INSPECTION REPORT  
Sedimentation Structure  
J16-K  
Kayenta Mine  
Navajo County, Arizona  
for  
PEABODY COAL COMPANY

Dames & Moore  
10139-011-22

EXISTING  
 MAXIMUM CROSS-SECTION  
 A-A'  
 J16-K

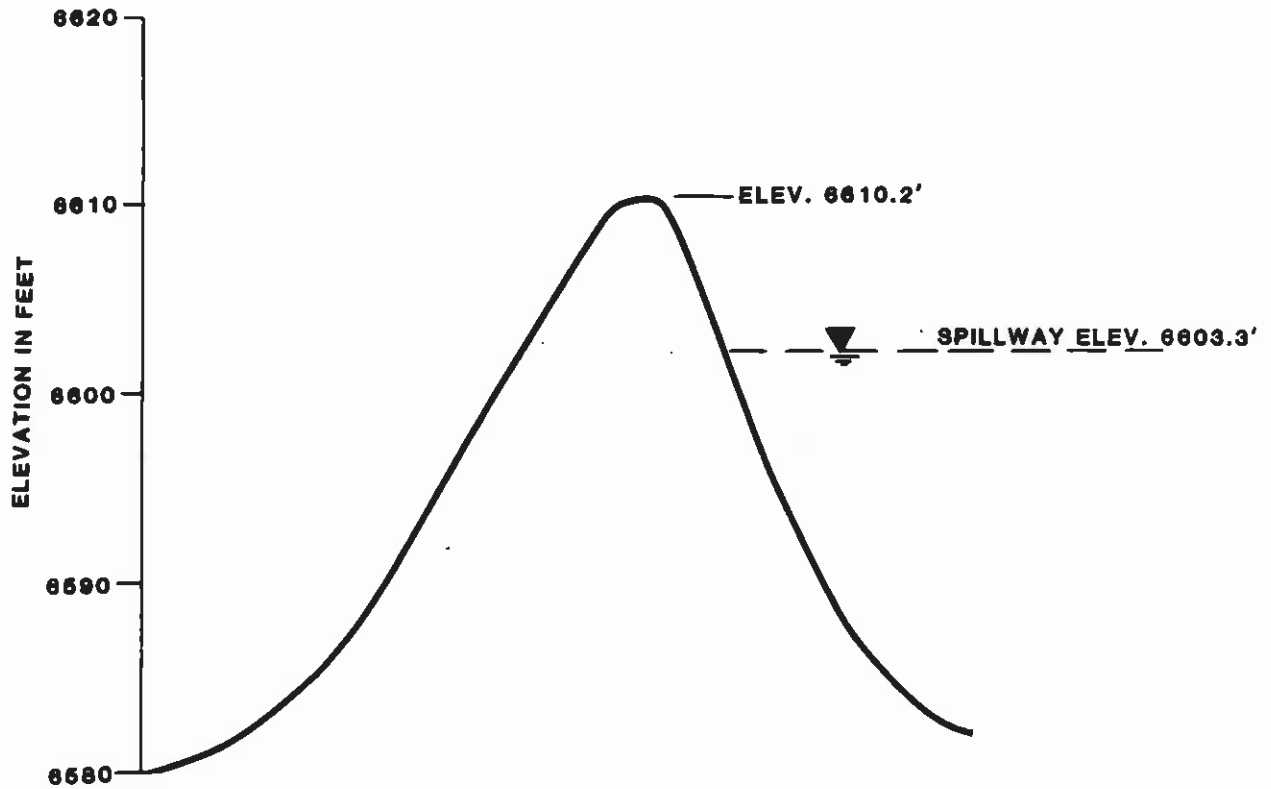
The J16-K embankment is lower in height; however, the downstream slope is steeper than the category standard; therefore, the embankment has factors of safety less than the design minimum.

and does not require remedial action. The downstream slope should be flattened to 4.25 horizontal to 1 vertical to meet stability requirements.

CHANNEL PROFILE B-B'  
J16-K

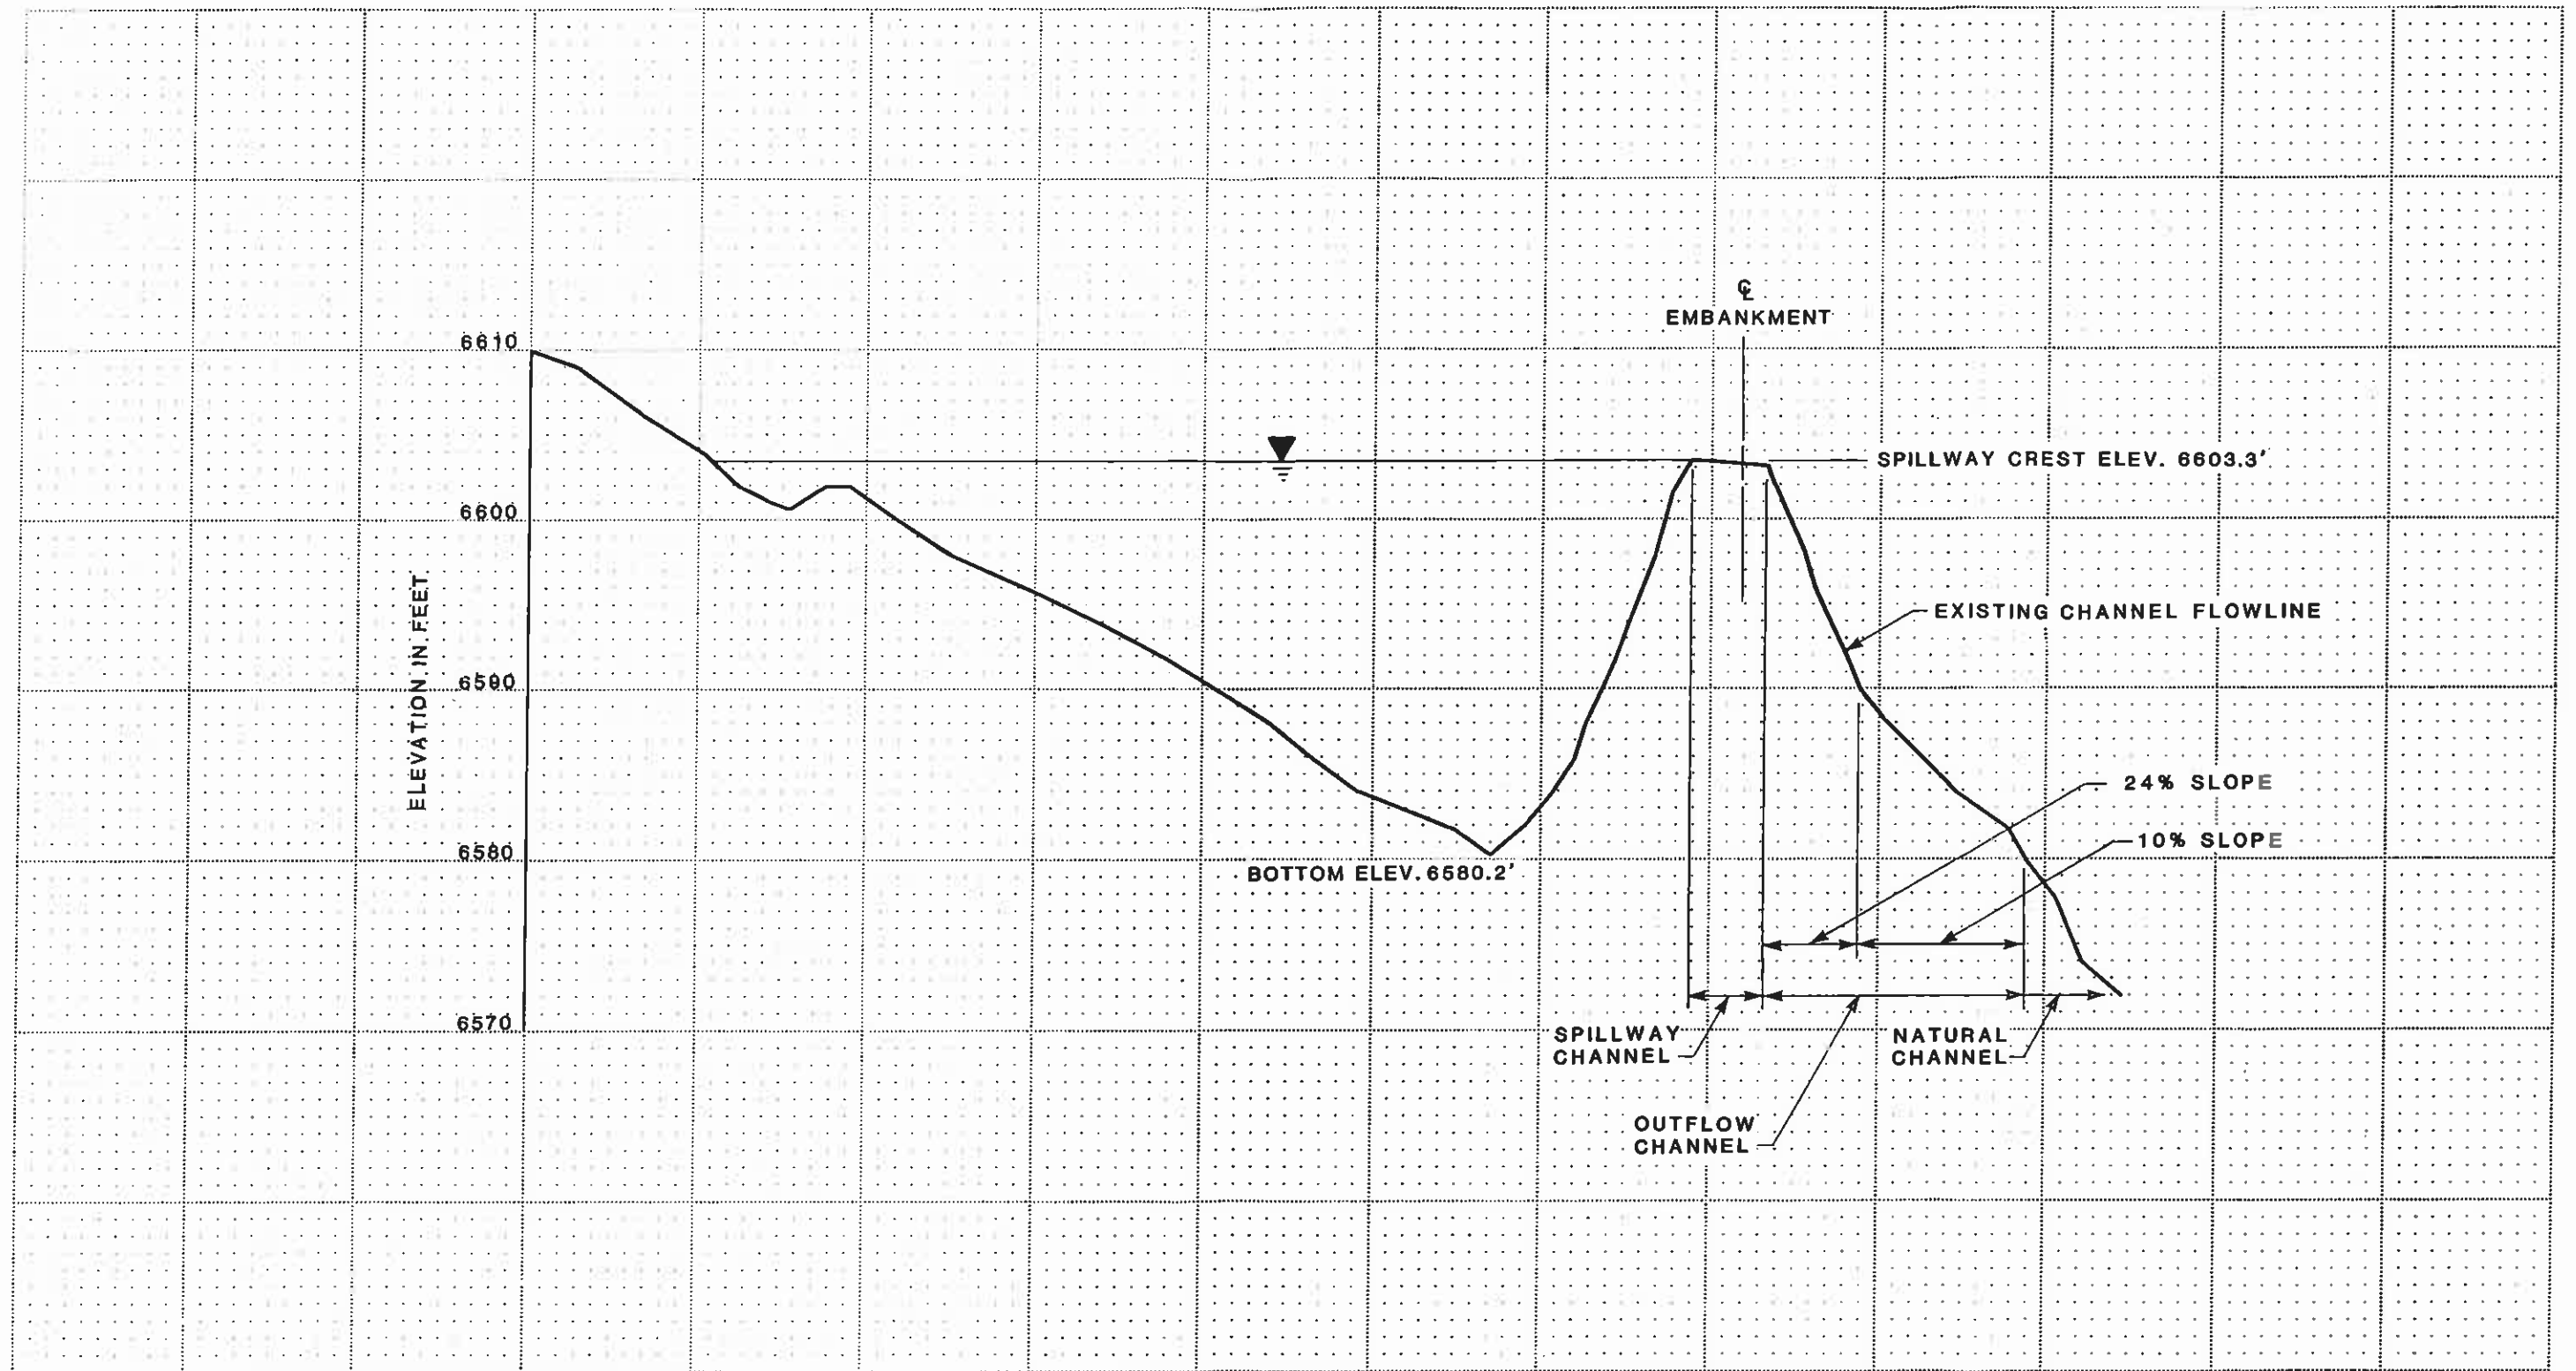
The storage capacity and spillway capacity of Structure J16-K are adequate. The outflow channel is protected with riprap but the spillway channel is not. The spillway channel should be protected against erosion using geotextile and riprap as shown in Plate 5. Plate 4 shows the existing spillway and outflow channel profile and Plate 5 shows the channel dimensions.

**SPILLWAY CHANNEL  
 CROSS SECTION  
 J16-K**

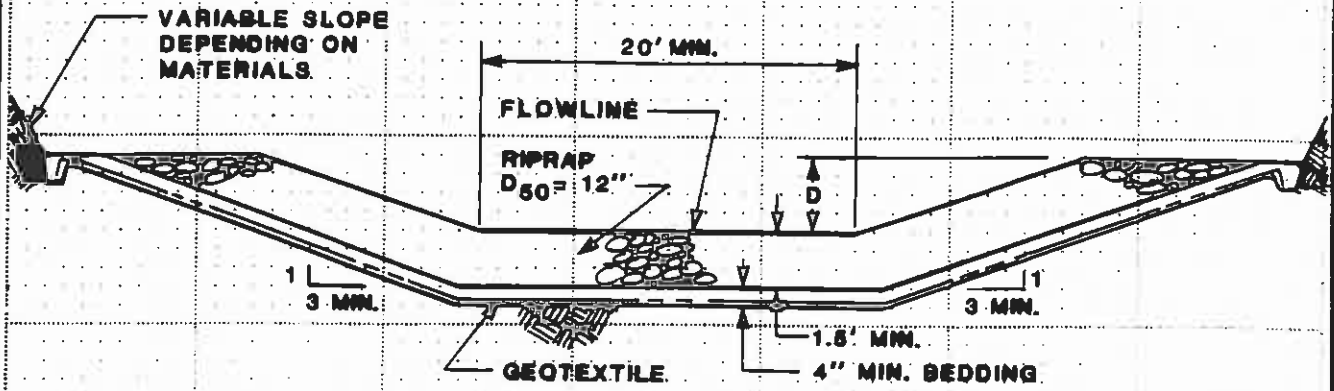
There is presently no erosion protection within the channel.

**SPILLWAY CHANNEL**  
 D = 2.7'  
 LENGTH = 60'  
 FLOWLINE ELEV. = 6603.30'
